EDINBURG PLANNING AND ZONING COMMISSION
CITY OF EDINBURG, HIDALGO COUNTY, TEXAS

JULY 23, 2026
5:30 PM

**MINUTES
PLANNING AND ZONING COMMISSION
CITY OF EDINBURG, HIDALGO COUNTY, TEXAS**

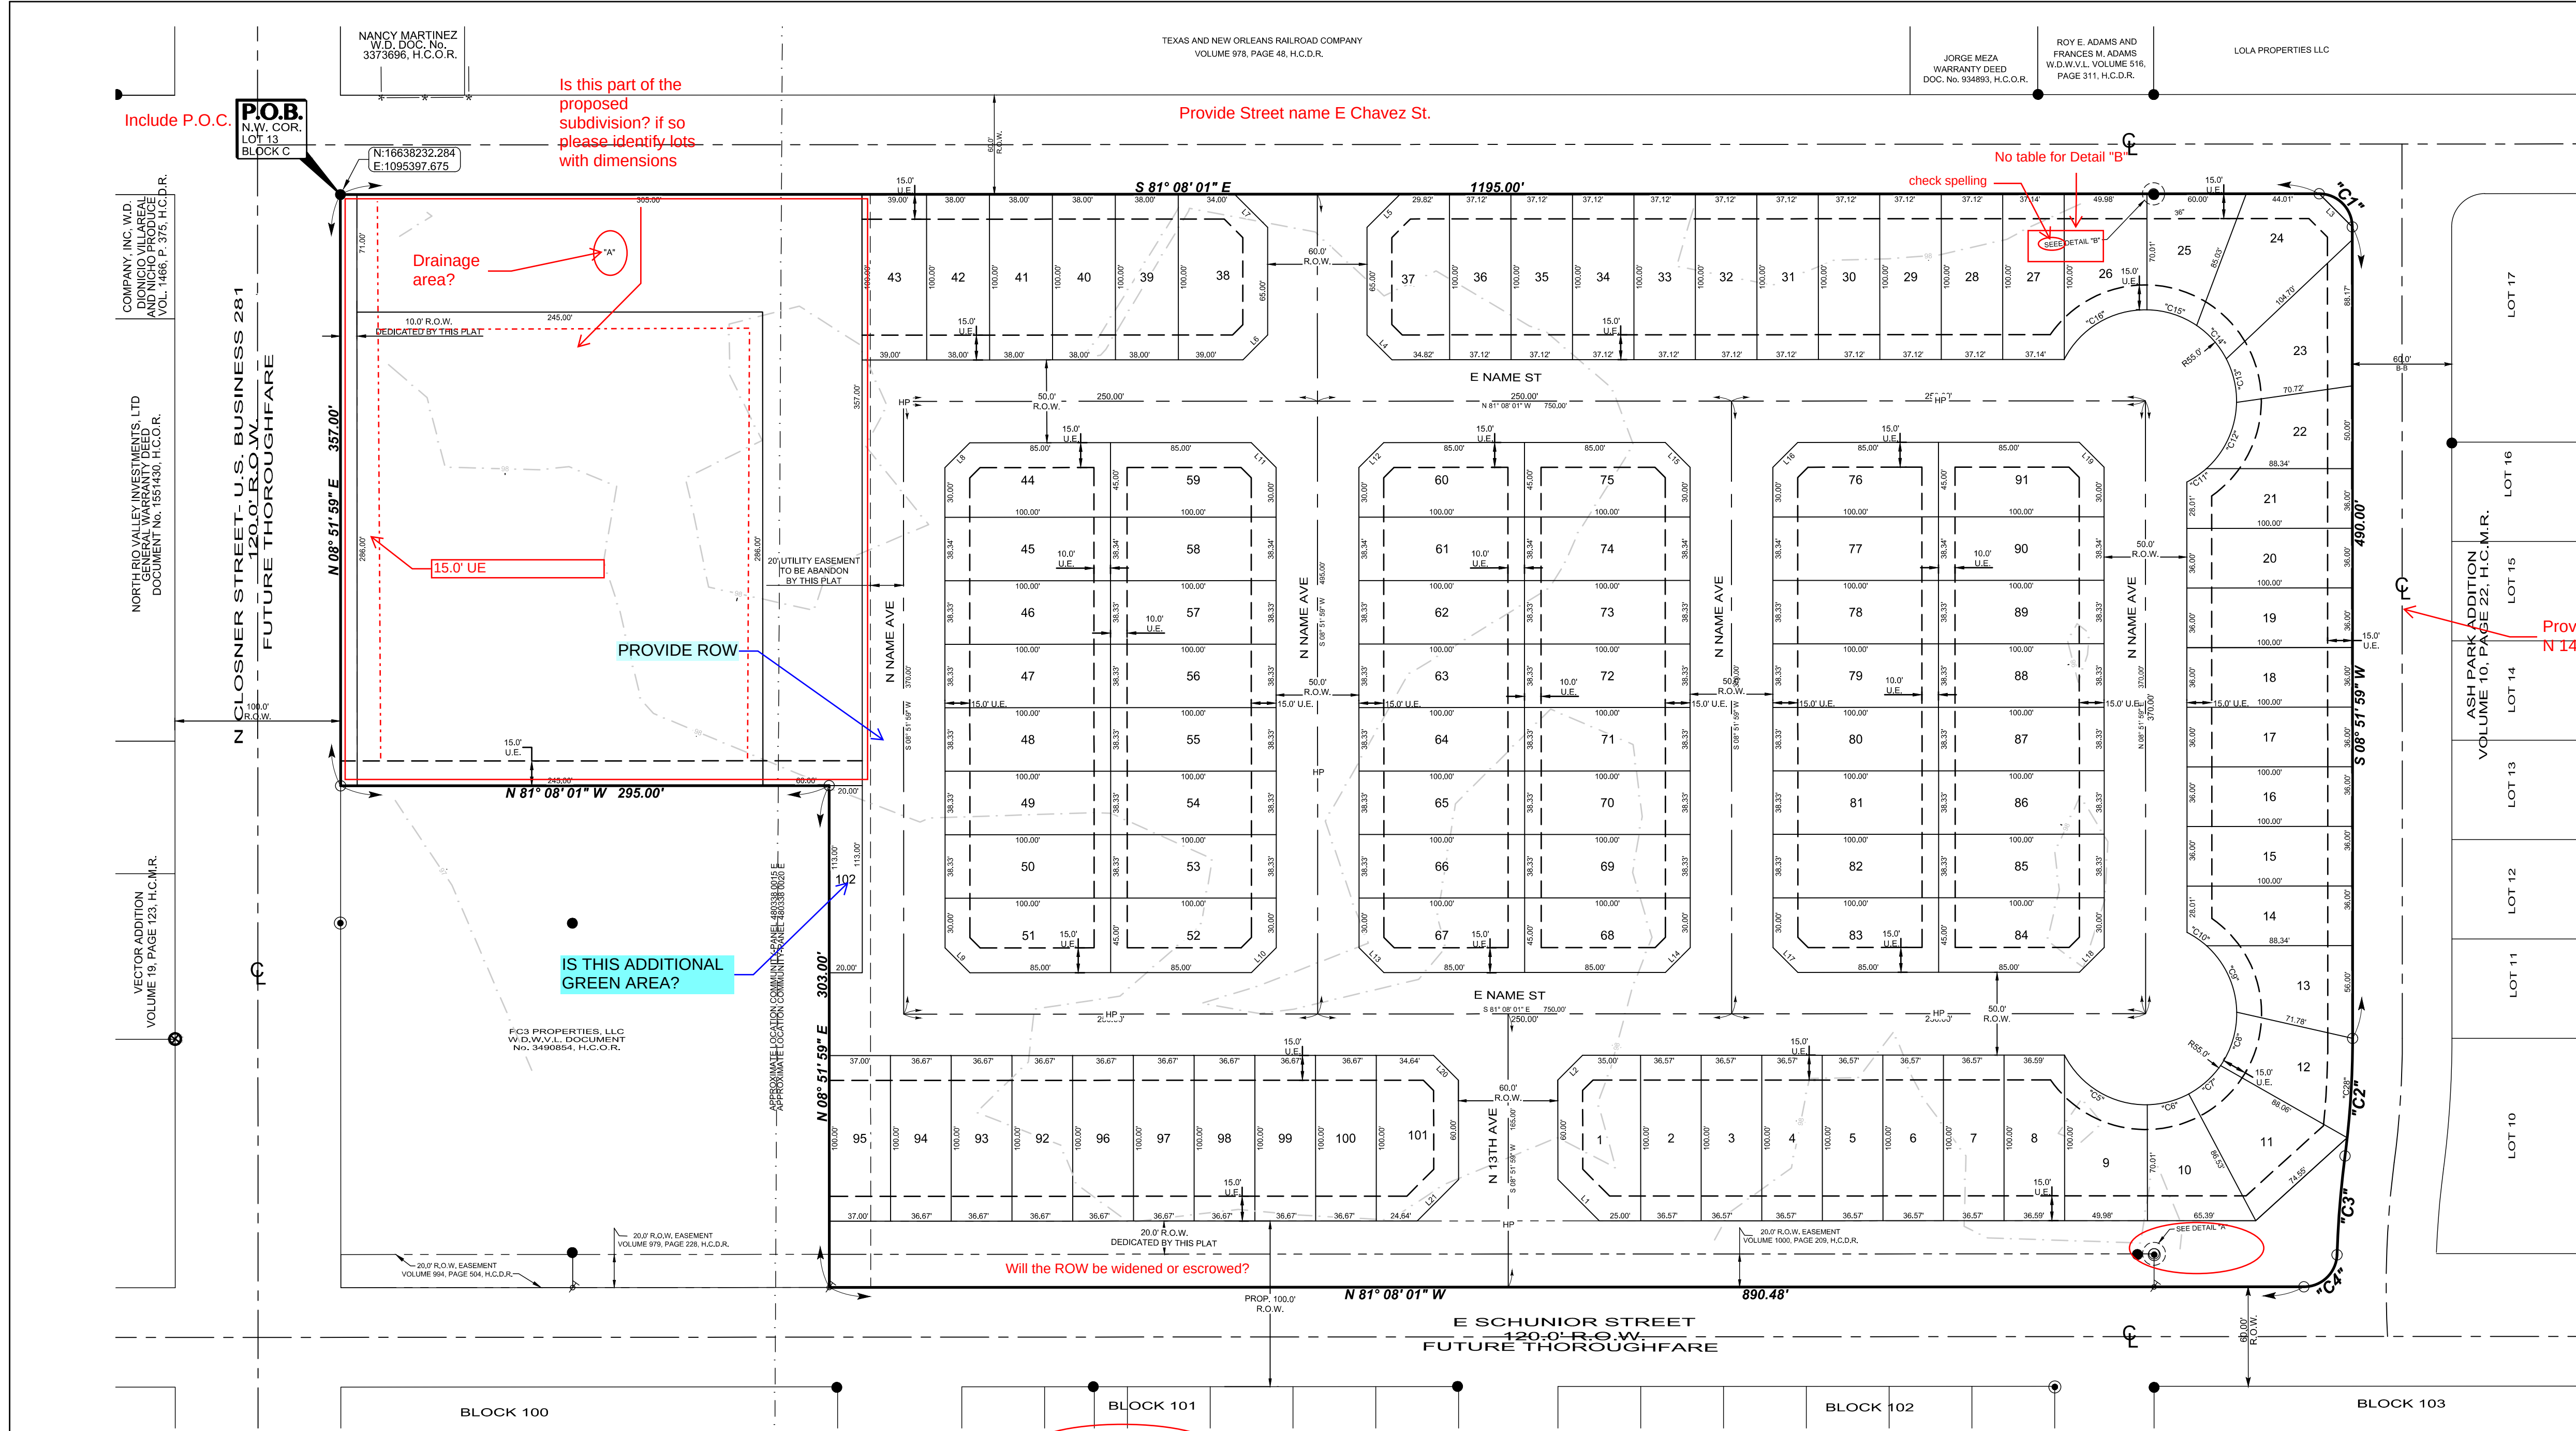
Verify street names with GIS team.

Missing 17, 18, & 19

Provide Street name N 14th PL

clarify what lot 102 is on the plat?

Lot 103 not on plat, please verify.

Provide Gate details

Verify location

(PRIVATE)
SUBDIVISION MAP OF
CLOSNER POINT SUBDIVISION
PLAT SHOWING 16.336 ACRES BEING ALL OF
LOTS 11 AND 12, AND OUT OF LOT 13, ALL OF BLOCK C
AMENDED MAP OF EDINBURG
AND BEING ALL OF LOTS 1 THROUGH 9
OF ASH PARK ADDITION
CITY OF EDINBURG, HIDALGO COUNTY, TEXAS

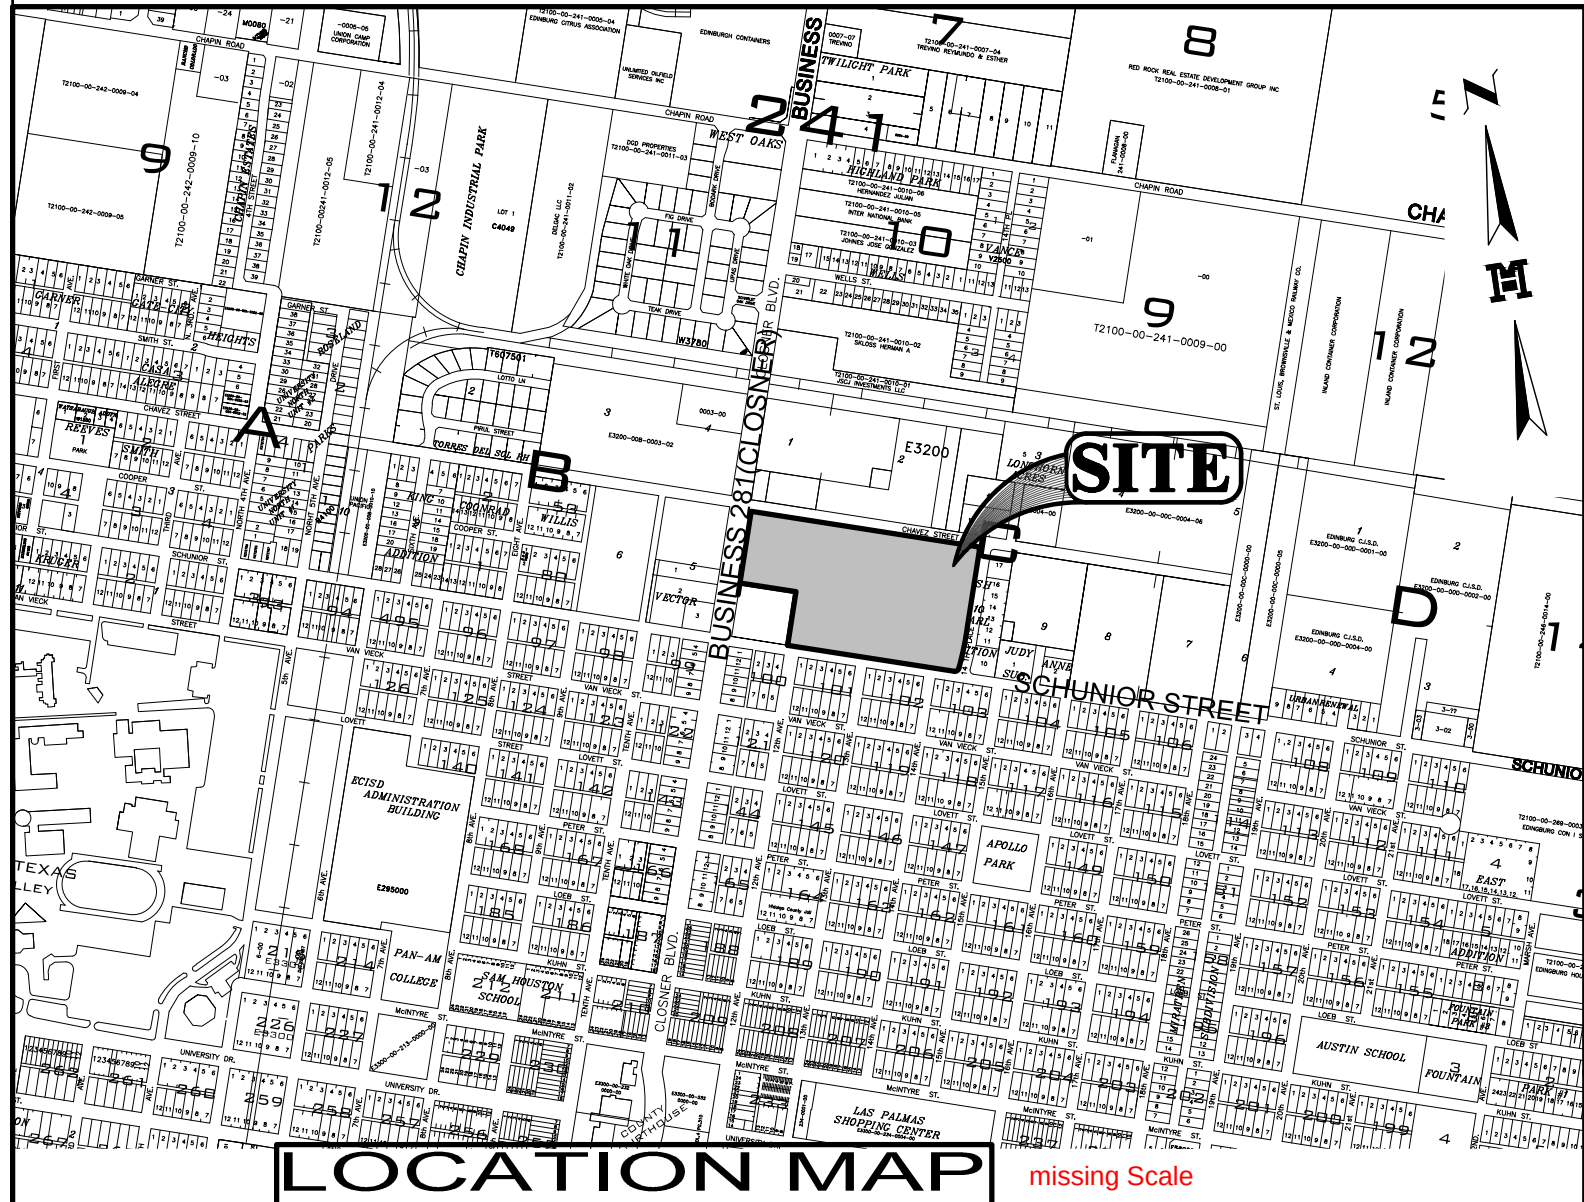
2. THIS PROPERTY IS BEING PROPOSED AS ZONED AS RESIDENTIAL URBAN. **Property is currently zoned Residential, Multifamily. Will property be rezoned? If so, subdivision will not get preliminary plat approval until subdivision is approved to rezoned by Planning and Zoning Commission and City Council.**

20. DETENTION POND AREA MUST BE MAINTAINED BY THE **HOME OWNERS ASSOCIATION** **HOA documents will have to be provided prior to recording**
21. THE FOLLOWING BENCHMARKS ARE IDENTIFIED ON THE FACE OF THE PLAT AND ON THE ATTACHED ENGINEERING PLANS, DATUM BASED ON TEXAS SOUTH 4205 ELEVATION PER NAVD 89 (GEOID 2003)

UTILITY LAYOUT

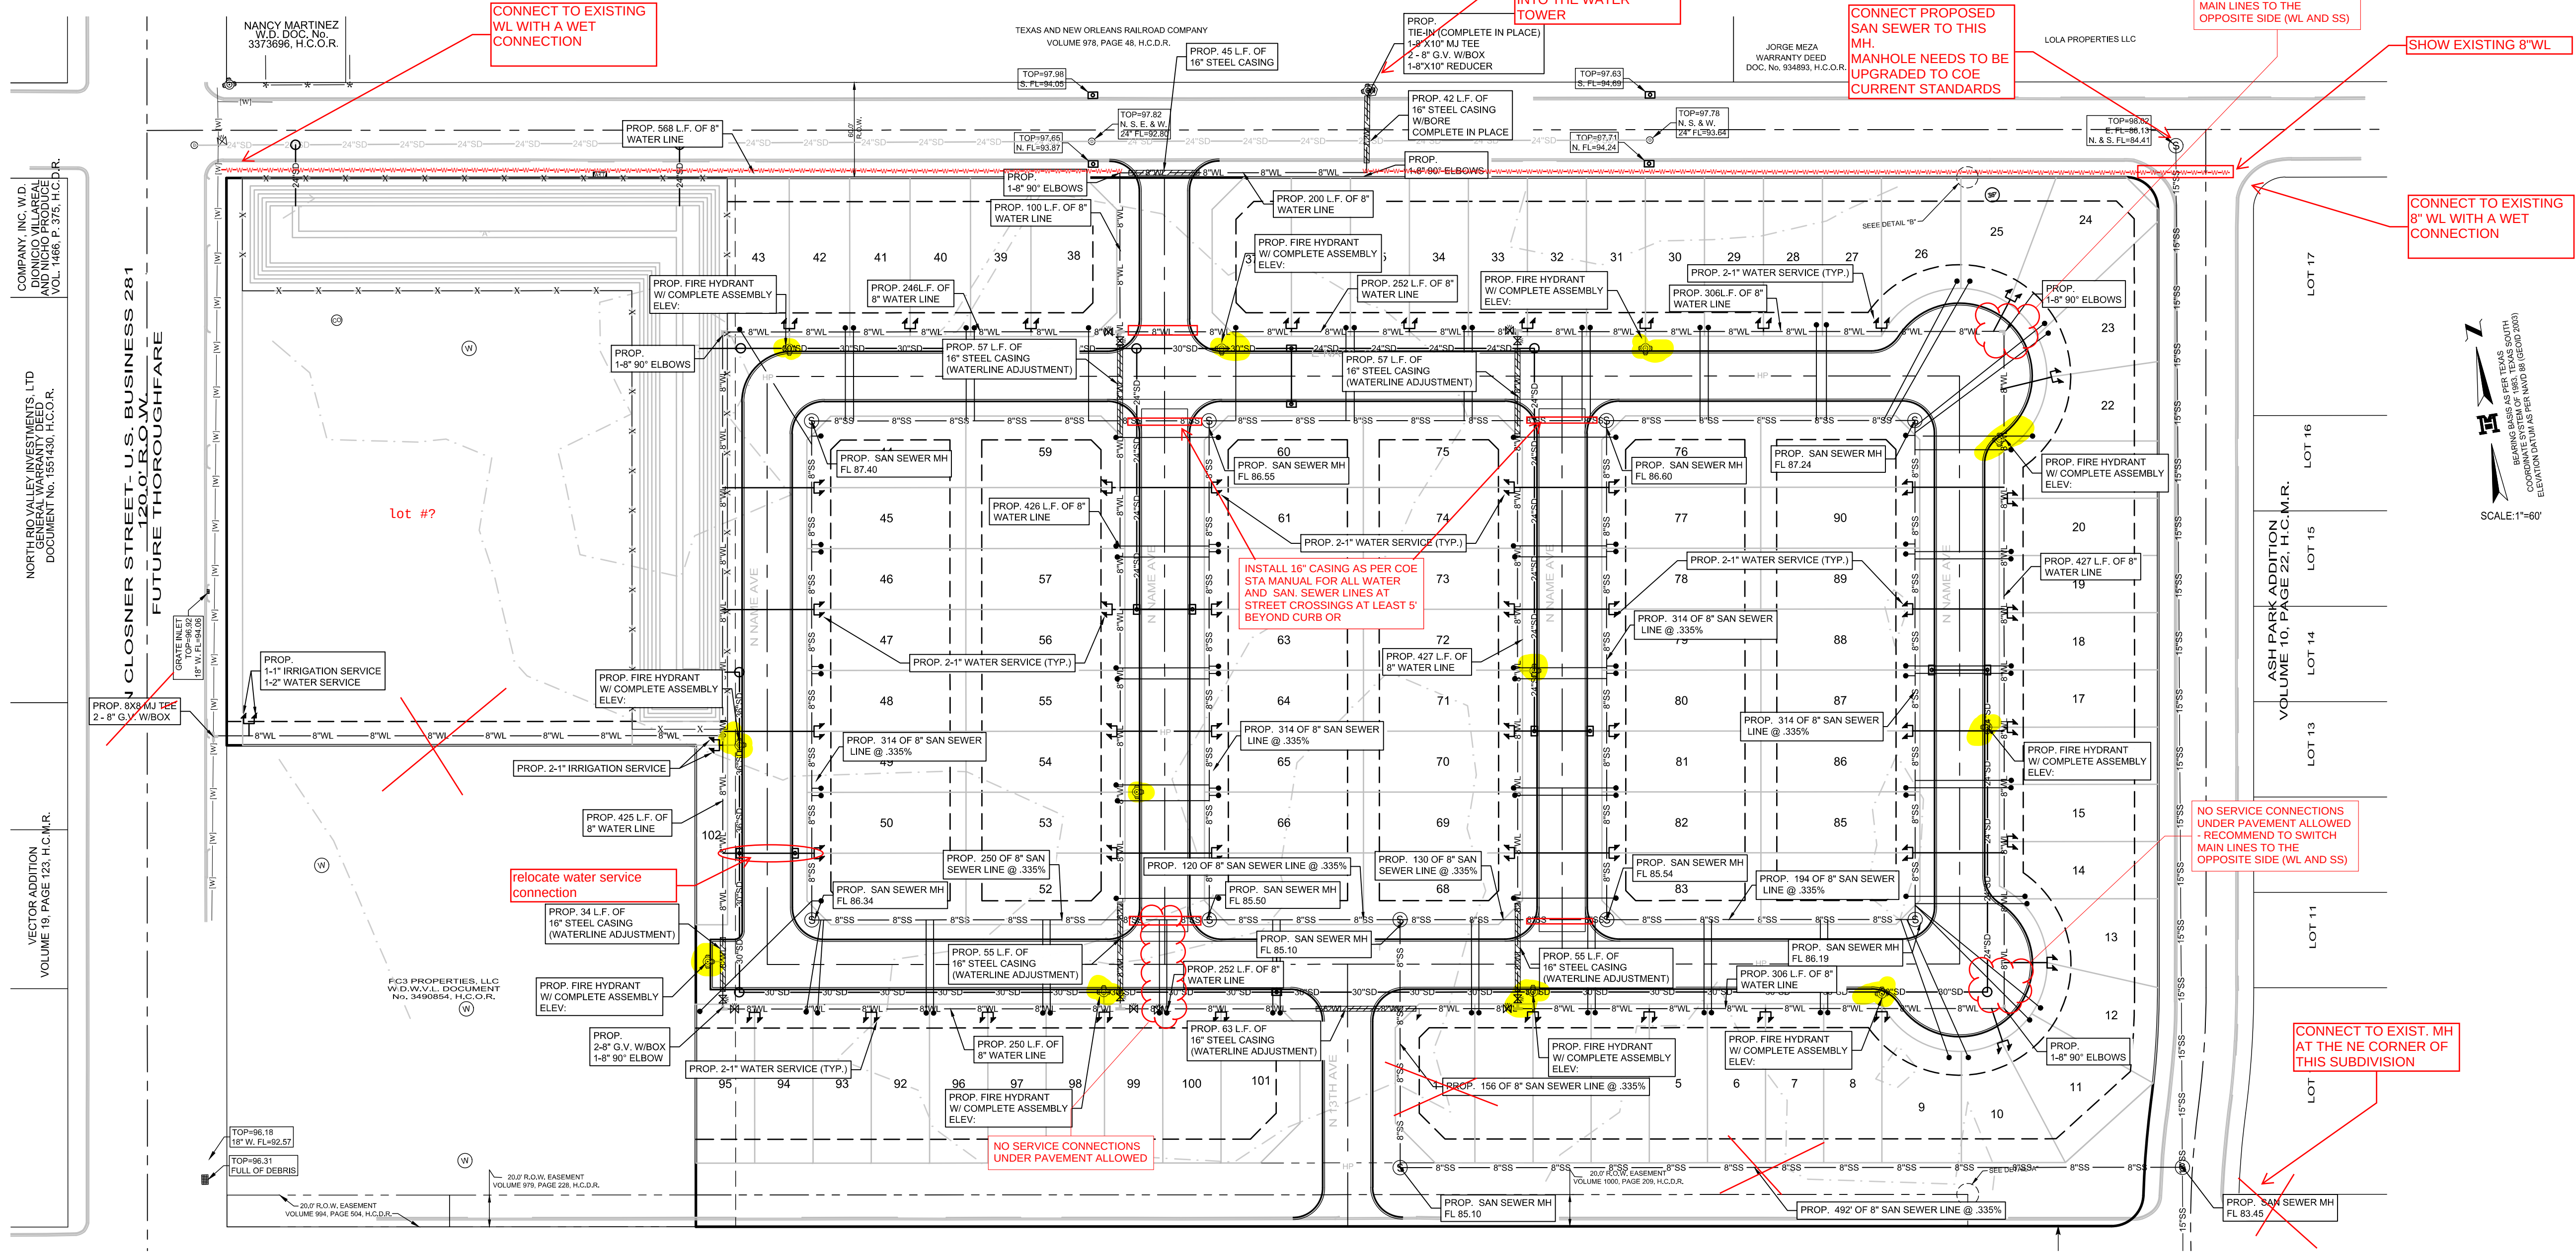
need to clarify if service will have a 2" shd
